Historical Architectural Review Board Certificate of Appropriateness Preliminary Review Sheet

File Number: HDC-2025-00021 Address: 412 N 8th Street District: Old Allentown

<u>Project Description</u>: Applicant proposes to legalize the installation of concrete steps and two black handrails along the 8th street elevation at 412 8th Street after receiving a letter from the insurance company requiring attention concerning the repair the porch steps and to installation of a handrail.

Porches 3.7

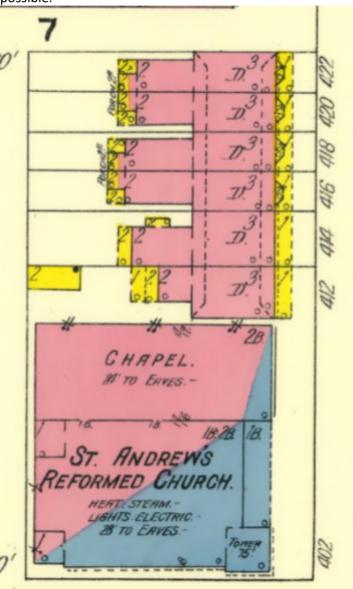
Staff was notified that wooden steps that had been installed at 412 N 8th Street had been removed and replaced with concrete steps. In addition to the installation of concrete steps the owner also installed two black metal hand railings leading to the main entrance.

The instalment of concrete steps and handrailing's at 412 N 8th Street fronting 8th street does not negatively impact the architectural integrity of the block but staff would encourage integrating a bullnose design to the preexisting steps, if possible, to more closely match existing concrete steps.

<u>Discussion:</u> Mr. Justiniano stated that his insurance company required the replacement of steps and installation of the railings. Mr. Huber noted that the step material and railings are appropriate per the Guidelines, but that the steps should have a bullnose to be consistent with the historic style. Mr. Huber noted that the bullnose is something that cannot be added afterwards; it is poured with the rest of the steps. The HARB discussed if concrete steps without a bullnose is appropriate, with respect to the Guidelines, and other examples of steps along the street.

Approval, pursuant to Chapter 3, Section 7 Porches and Steps.

<u>Actions:</u> Ms. Westerman moved to approve the application as presented on April 7, 2025, for the legalization of concrete entry steps and railings at 612 N 8th Street, following sections of the Guidelines for Historic Districts: Chapter 3, 3.7-Porches and Steps and find no circumstances unique to the property. Mr. Hart seconded the motion, which carried with unanimous support and no abstentions.
